Access Compliance Report

Public Rights-of-Way

Intersection ID: 28373	Main Street: ASTOR_HALL_DR	Cross Street: SOUTHAMPTON_COMMONS_DR	Location: NE
ADA ID: 67E390A05026	Ramp Type: Perp	Initial Pass/Fail: Fail	Overall Compliance: No
Severity Score: 12.5			
Codes/Mitigation Info/Possible Solution		Field Measurements/Component Compliance

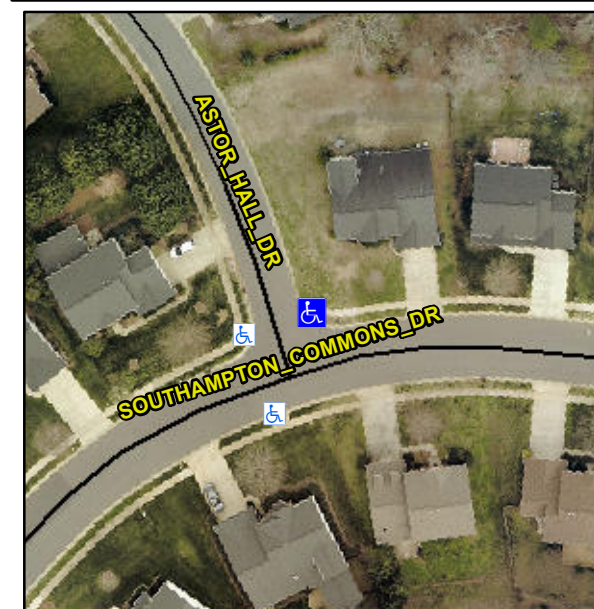
Not Found, R304.5.3

Compliance	Description	Data	Compliance	Description	Data
N/A	Ramp Length (in)	51.0	Yes	Ramp Slope (%)	5.1
Yes	Ramp Width (in)	48.0	No	Ramp XSlope (%)	6.7
N/A	Flare Type LT	N/A	N/A	Flare Type RT	N/A
N/A	Flare Slope LT (%)	N/A	N/A	Flare Slope RT (%)	N/A
N/A	Flare Traversable LT?	N/A	N/A	Flare Traversable RT?	N/A
N/A	Landing Length (in)	N/A	N/A	DWS Provided?	N/A
N/A	Landing Width (in)	N/A	N/A	DWS Contrast?	N/A
N/A	Landing Slope (%)	N/A	N/A	DWS Length (in)	N/A
N/A	Landing X Slope (%)	N/A	N/A	DWS Full Width?	N/A
N/A	Landing Curb? (Y/N)	N/A	N/A	DWS Offset (in)	N/A
N/A	Shared Landing?	N/A			
N/A	Gutter Ponding?	N/A	N/A	Gutter Slope (%)	N/A
N/A	Gutter Lip Ht (in)	N/A	N/A	Gutter X Slope (%)	N/A
N/A	Painted X Walk1?	No	N/A	Painted X Walk2?	N/A
	X Walk 1 Direction	To W		X Walk 2 Direction	N/A
N/A	X Walk 1 Width (in)	N/A	N/A	X Walk 2 Width (in)	N/A
	X Walk 1 Slope (%)	4.5		X Walk 2 Slope (%)	N/A
	X Walk 1 X Slope (%)	2.5		X Walk 2 X Slope (%)	N/A

Remove & Replace Entire Ramp.
